BEFORE THE  
PUBLIC UTILITIES COMMISSION  
OF THE STATE OF CALIFORNIA

Application No. 10-01-014

**ALLIANCE FOR NUCLEAR RESPONSIBILITY'S  
OPENING BRIEF**

**Figure 1.** Alternative 3D Marine HESS Racetrack, plan submitted to CA SLC by PG&E January 2012, with suggested revised 3D Marine HESS Racetrack panels and on-land 2D Vibroseis lines plotted.

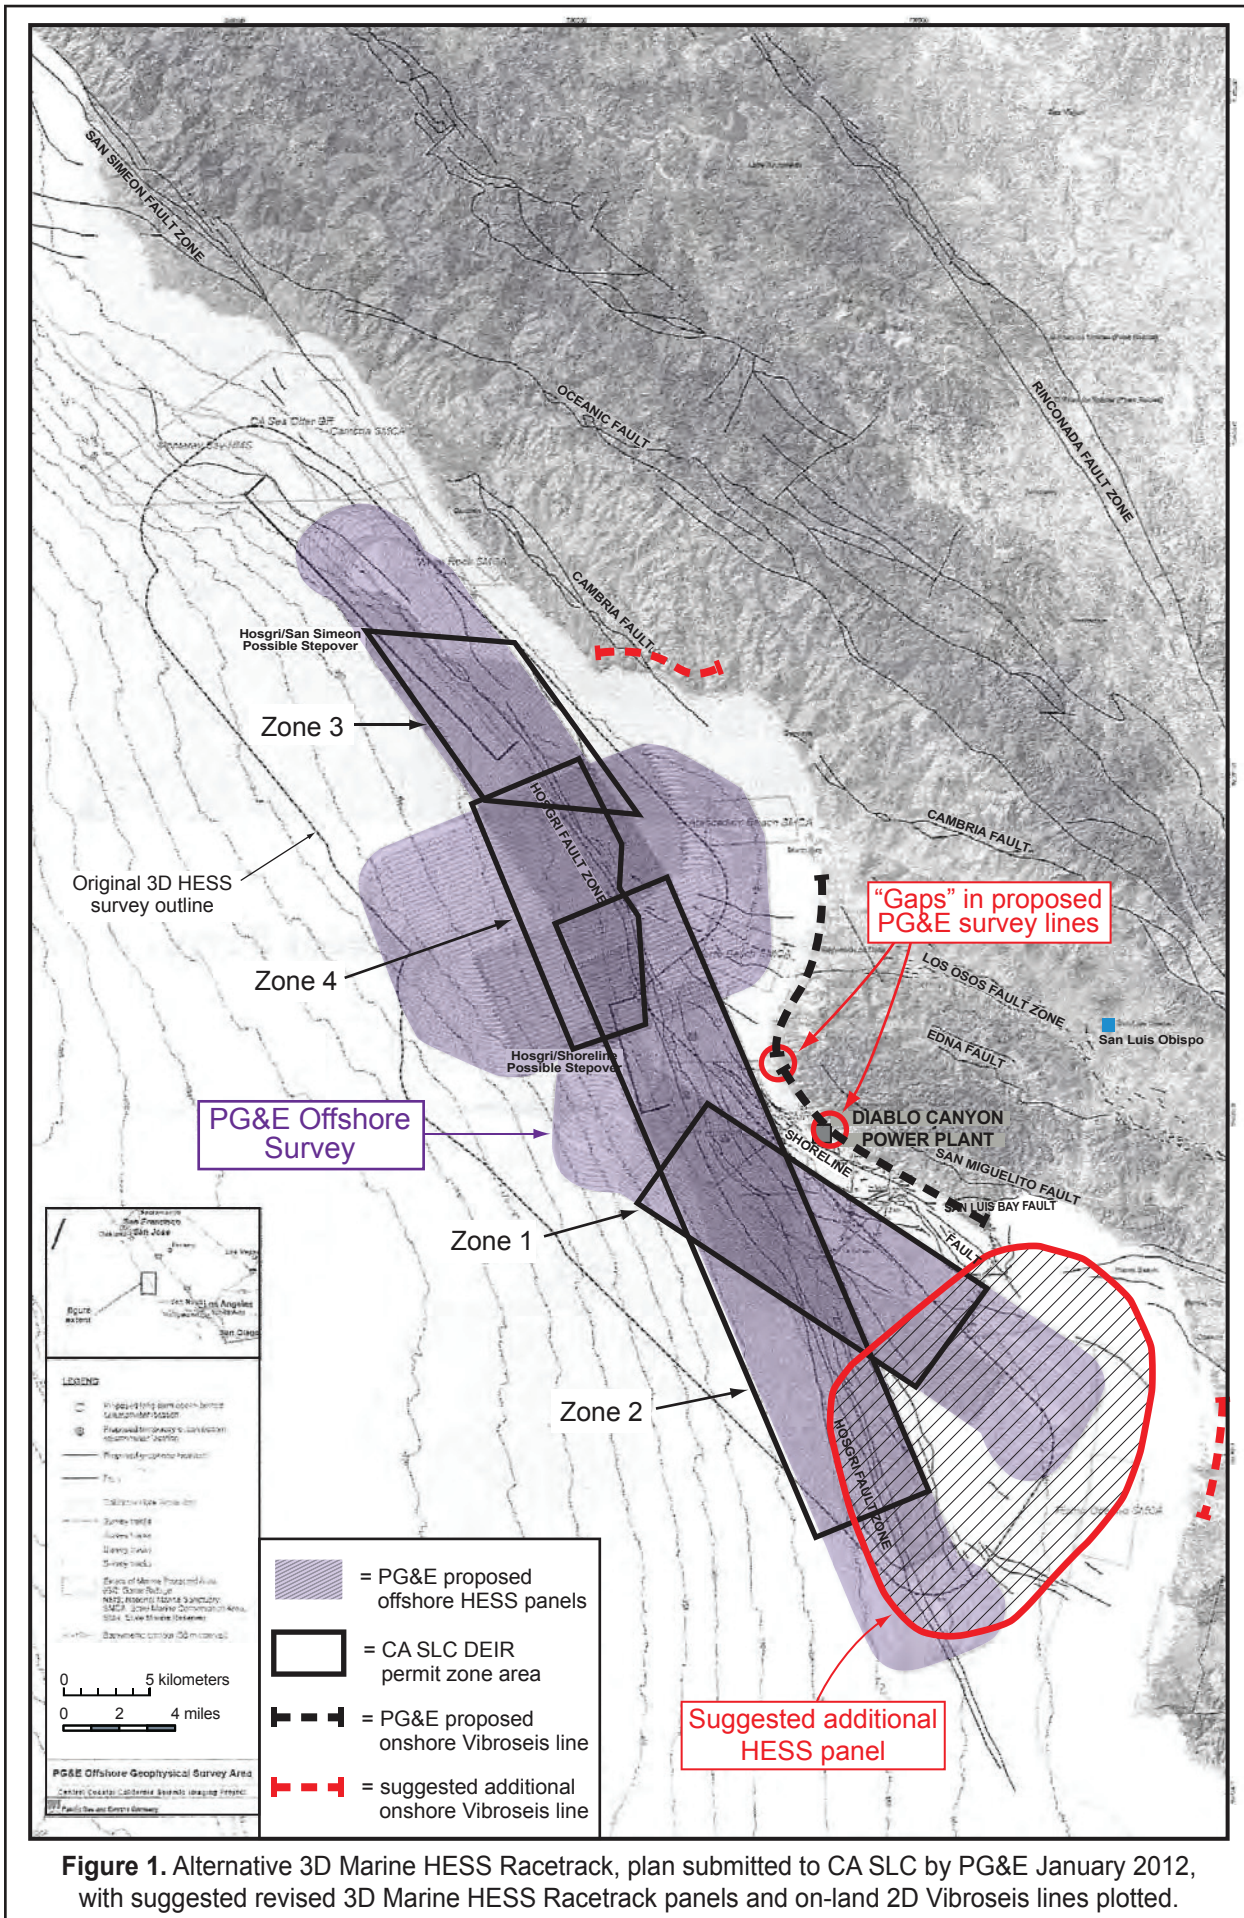
**A4NR Recommendation: The CPUC should direct PG&E to configure its onshore and offshore seismic surveys to specifically address Dr. Douglas Hamilton’s testimony concerning the Diablo Cove Fault and the San Luis Range/Inferred Offshore Fault and their interaction.**

<sup>41</sup> Consistent with PG&E’s attempt to find refuge in seismic work largely completed by 1988, A4NR suggests the Commission adhere to President Reagan’s famous neologism: trust, but verify. Maps identifying Dr. Hamilton’s areas of concern are attached to this brief as an Appendix and have been submitted to the State Lands Commission permitting process by geologist Erik Layman.

**Figure 2.** PG&E Proposed Nearshore Geophone Line Routes and Onshore Survey Lines

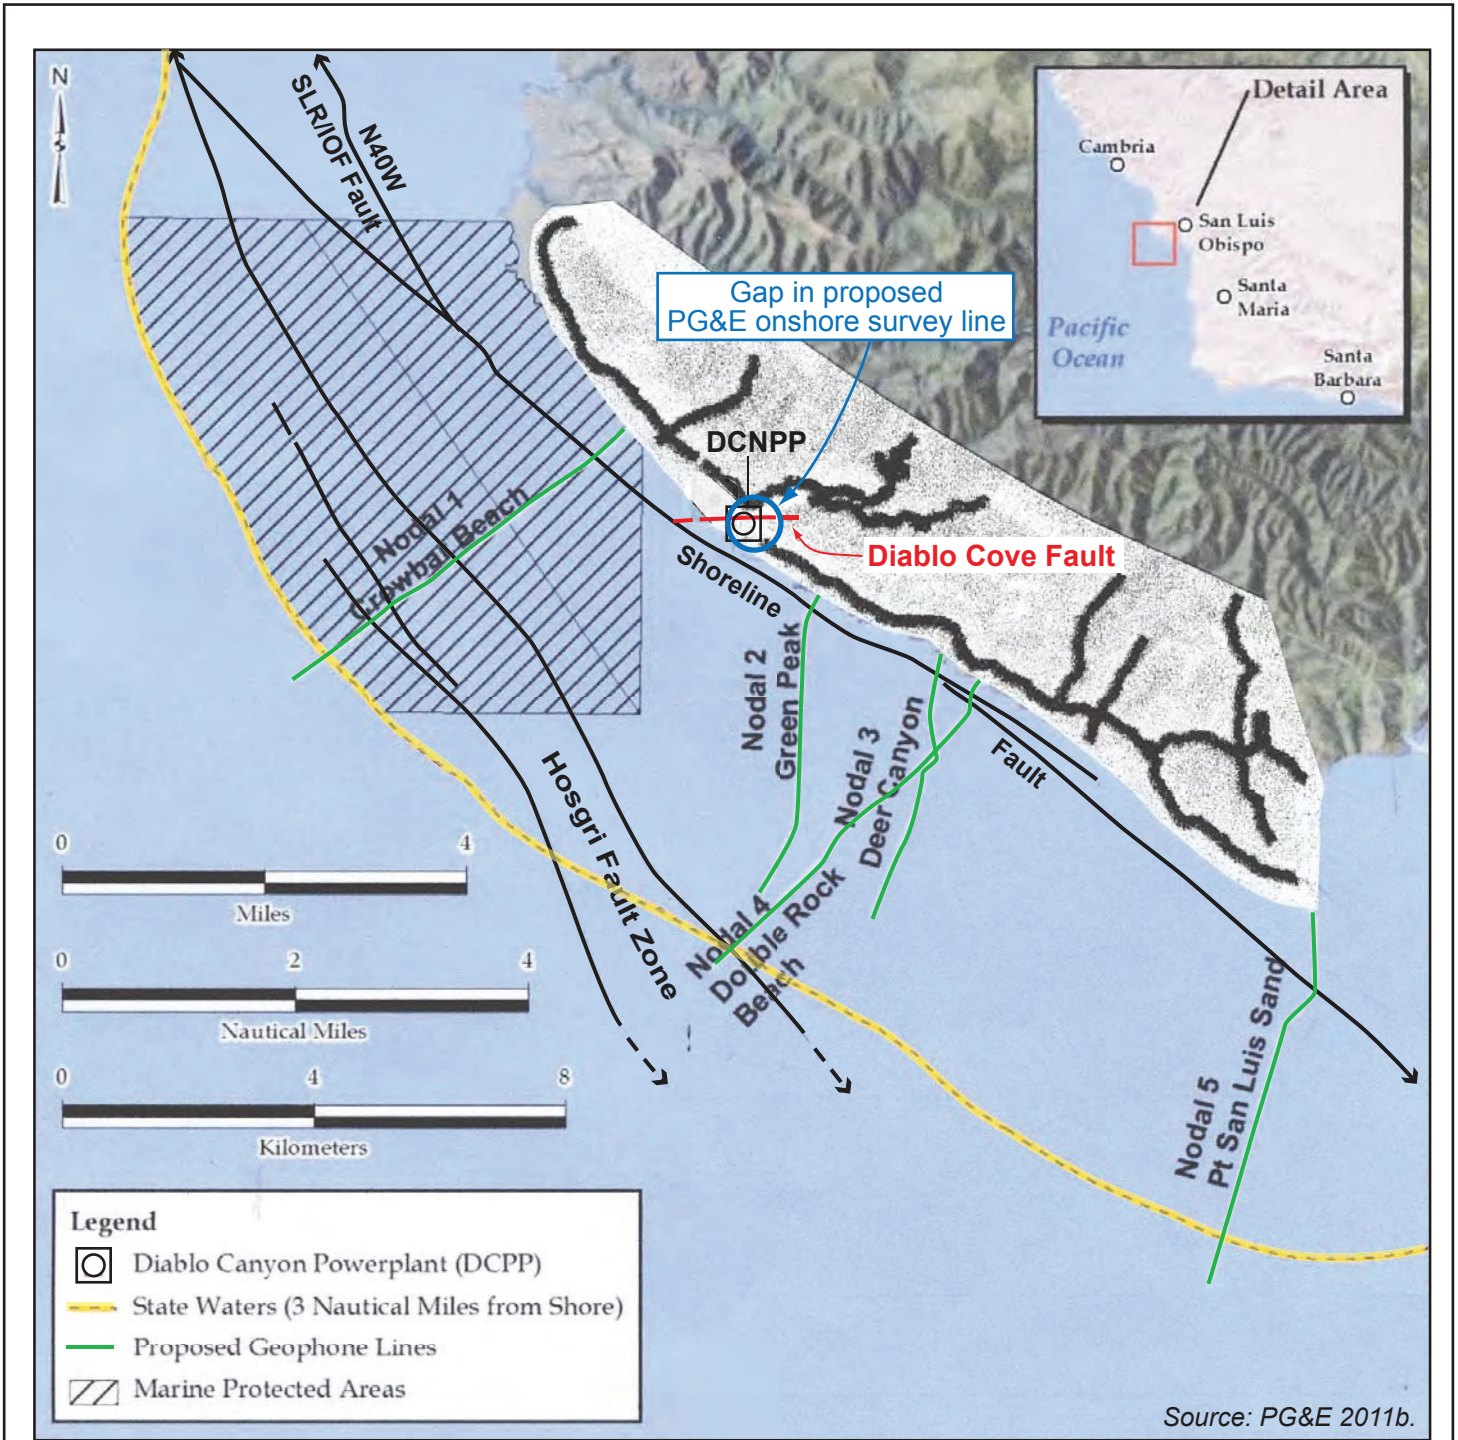
*Q: The draft environmental impact report for your studies shows a gap in the proposed vibroseis 2-D lines along the Irish Hills shoreline, does it not?*

*Q: Well, I’m referring exactly at the location of the so-called Diablo Cove fault.*

**Figure 3.** Suggested revised marine HESS Rerack panels and on-land Vibroseis lines, plotted on "Figure 7, Earthquake focal mechanisms, Irish Hills and adjacent offshore region, 1978-2011" from McLaren (SSHAC), 2011

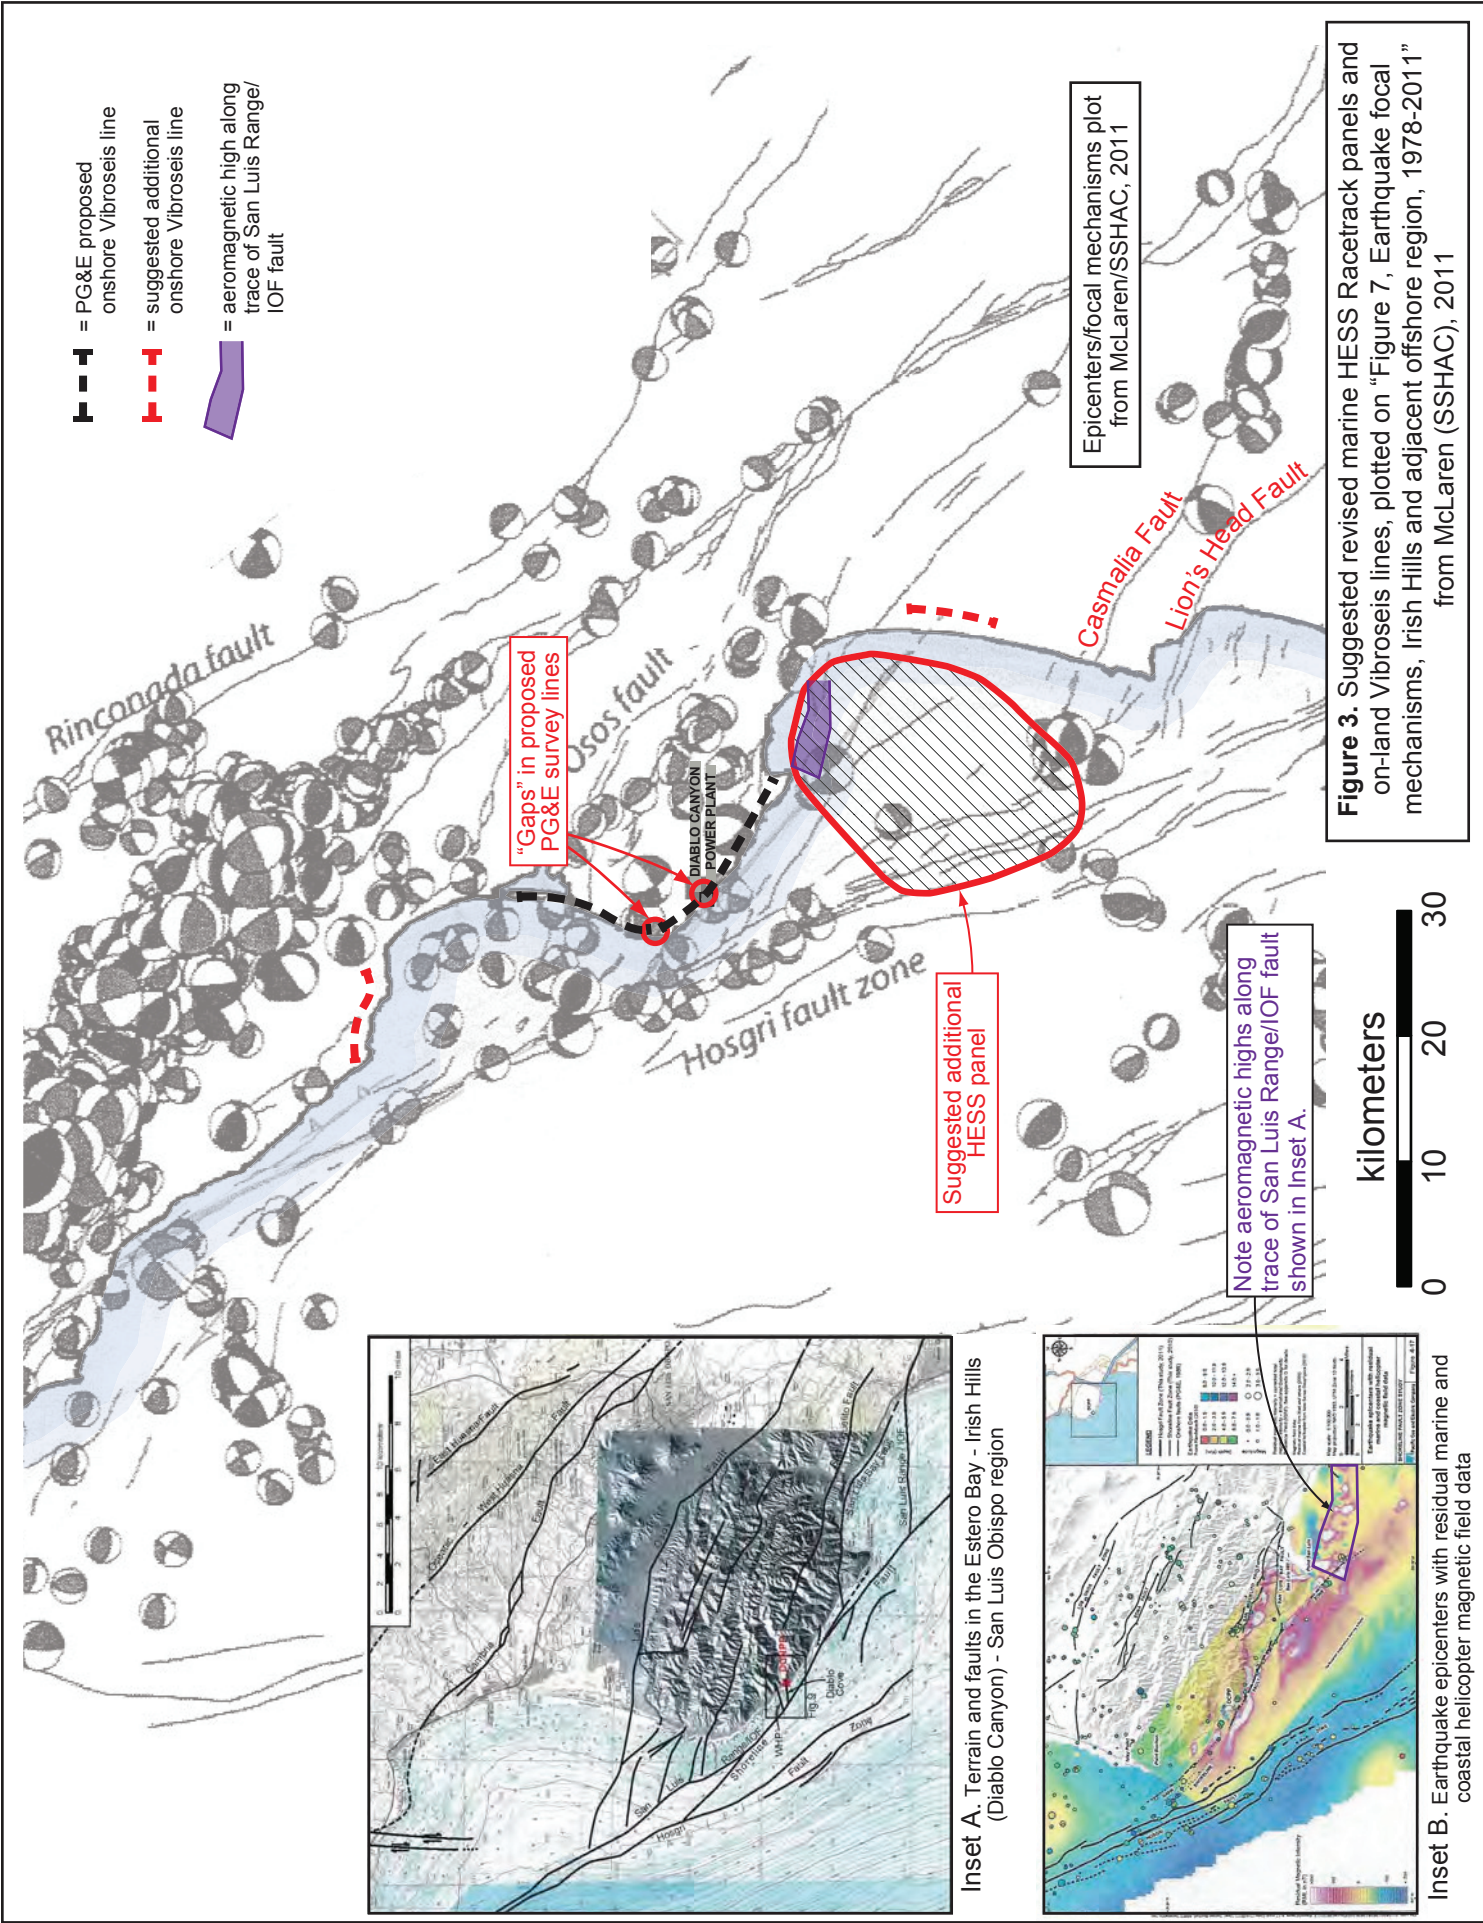
"Gaps" in proposed PG&E survey lines
